ITEM	8, 8A and 10-14 West Terrace, BANKSTOWN NSW
	Construction of a mixed commercial and residential development comprising of 12 commercial tenancies, 143 residential units and basement car parking.
FILE	DA-739/2014 - JRPP Reference: 2014SYW105
ZONING	3(c) – Business CBD
DATE OF LODGEMENT	25 July 2014
APPLICANT	Architecture and Building Works Pty Ltd
OWNERS	Kaymet Corporation Pty Ltd, T. B. & L. Kayrouz and W. J. & Y. W. Metlej
ESTIMATED VALUE	\$35,350,467
SITE AREA	4048m²
AUTHOR	Development Services (Sindhu Kaphle)

SUMMARY REPORT

DA-1119/2013 ASSESSMENT REPORT

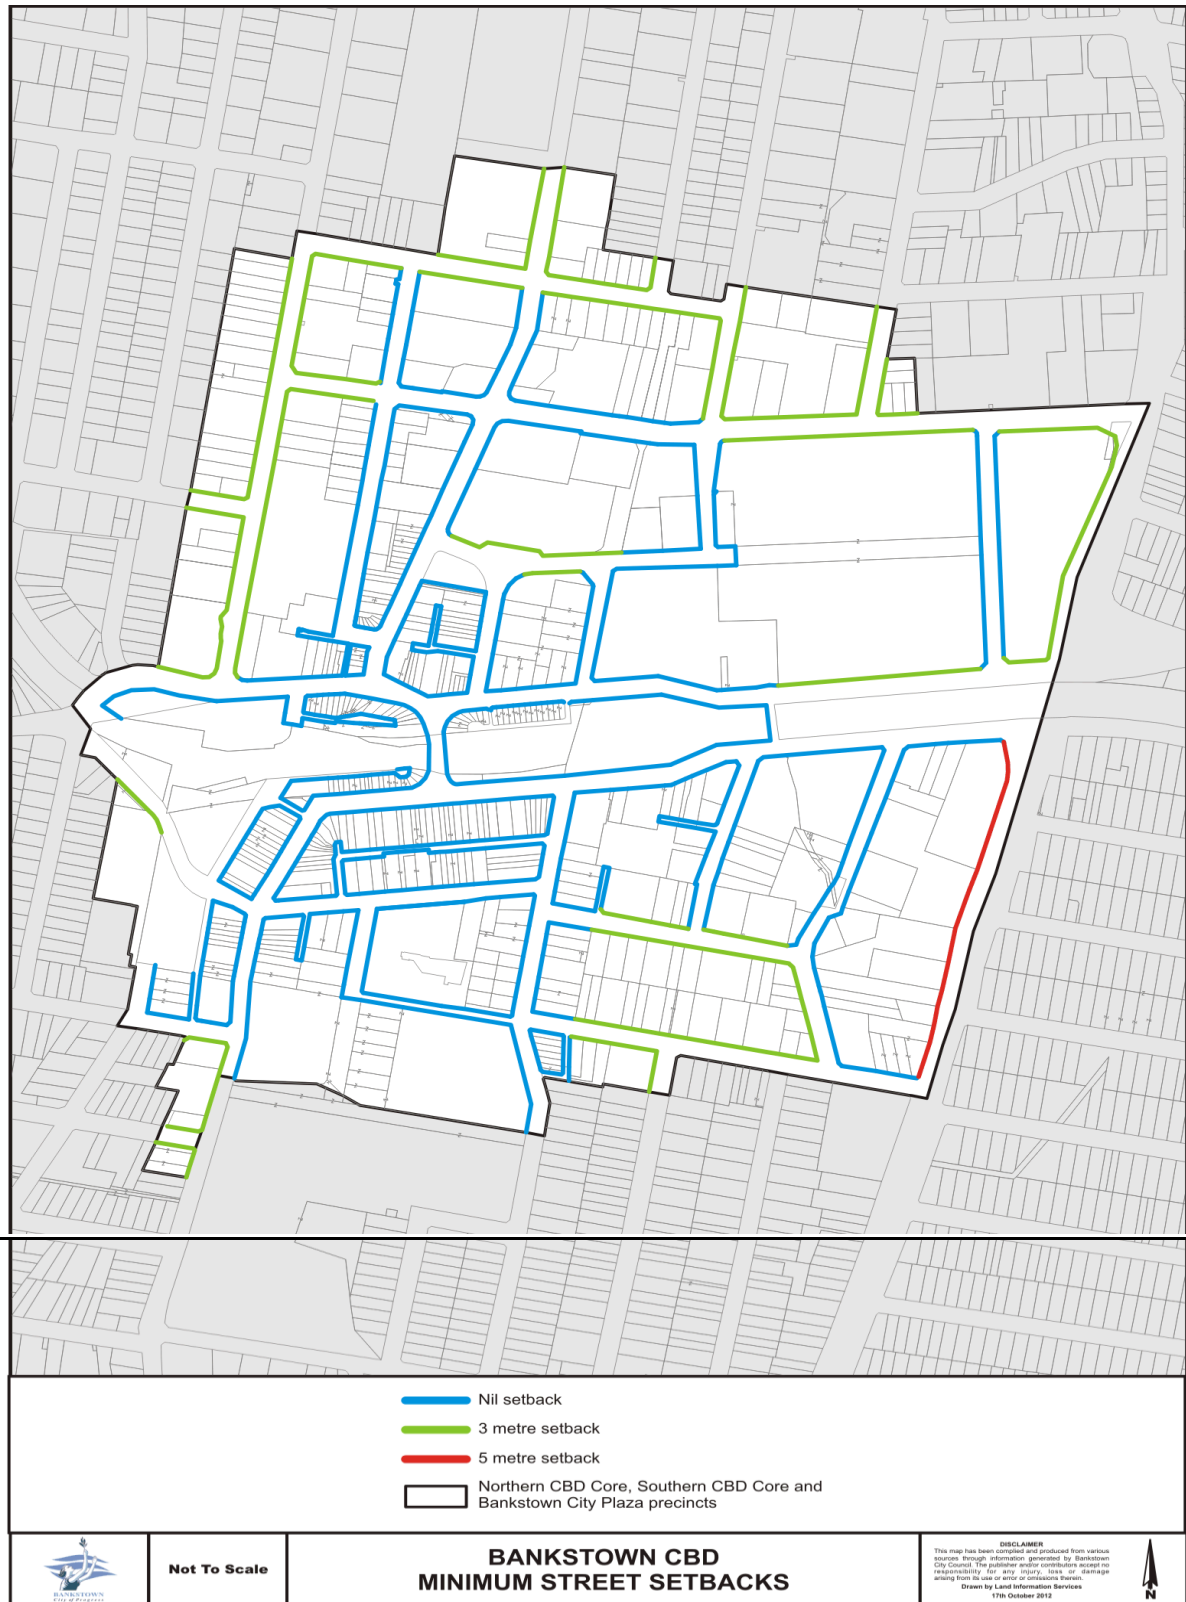
Clause 2.1 of Part D4 of BDCP states that the development must comply with the minimum street setbacks as shown in Figure 3 below. The relevant objective of the setback control is:

The street has an established built form with the setbacks varying from nil setback to approximately 8m. Whilst there are buildings located at nil setback on the western side of the street the existing multi-storey developments to the north and south of the subject site are setback 5m to 8m from the front boundary. Given the surrounding context and the established built form the proposed 3m setback is considered satisfactory for the site.
